Federal Motor Vehicle Safety Standards; Platform Lifts for Motor Vehicles; Platform Lift Installations in Motor Vehicles

ACTION: Final rule.

SUMMARY: This document adopts amendments to the Federal motor vehicle safety standards on platform lift systems for motor vehicles. The purpose of these standards is to prevent injuries and fatalities during lift operation. NHTSA believes it is necessary to revise the lighting requirements for lift controls; the location requirements, performance requirements, and test specifications for threshold warning signals; the wheelchair retention device and inner roll stop tests; and the lighting requirements for public use lifts. This notice also discusses a November 3, 2005 interpretation clarifying specific procedures that are performed as part of the threshold warning signal test.

**PLATFORM THRESHOLD AREA AUDIBLE
WARNING MEASUREMENT POINT
FIGURE 2**

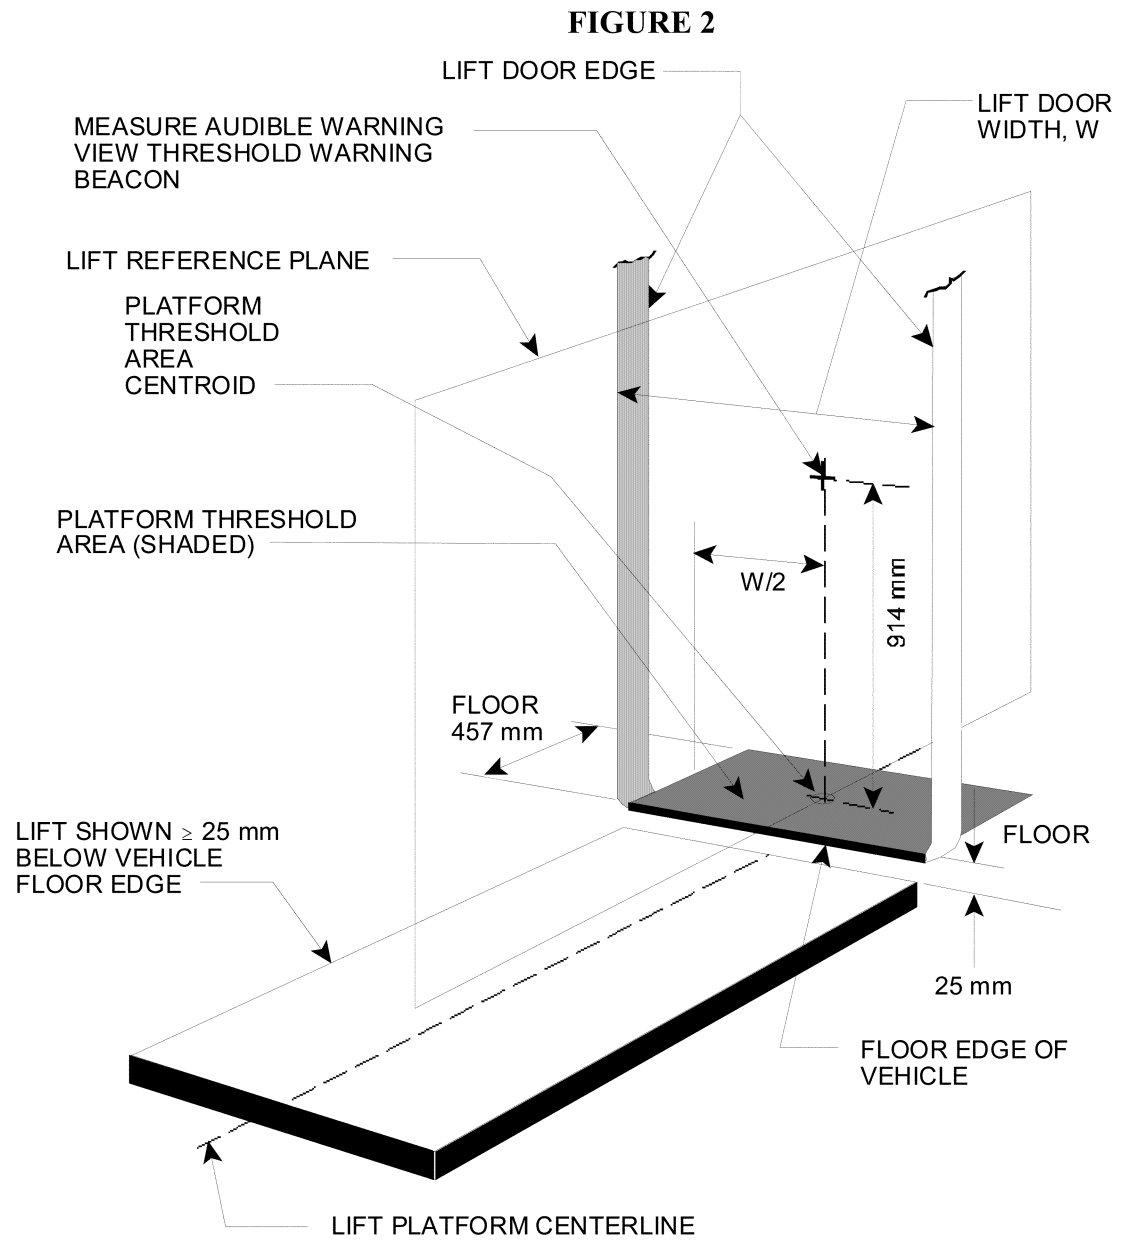
NHTSA also proposed a correction to Figure 2 of FMVSS No. 403. Currently, the height of the measurement point from which the intensity of the threshold audible warning is measured is identified as 919 mm. The proposed amendment would replace that distance with the correct measurement point of 914 mm (3 feet).

candela, a frequency from 1 to 2 Hz, and must be located within the interior of the vehicle such that it is visible from a point 914 mm (3 ft) above the center of the threshold area (see Figure 2) wherever the lift is installed and with any configuration of the vehicle interior.

S6.1.6 The intensity of the audible warning and visibility of the visual warning required by S6.1.2 and S6.1.3 is measured/observed at a location 914 mm (3 ft) above the center of the platform threshold area. (See Figure 2).
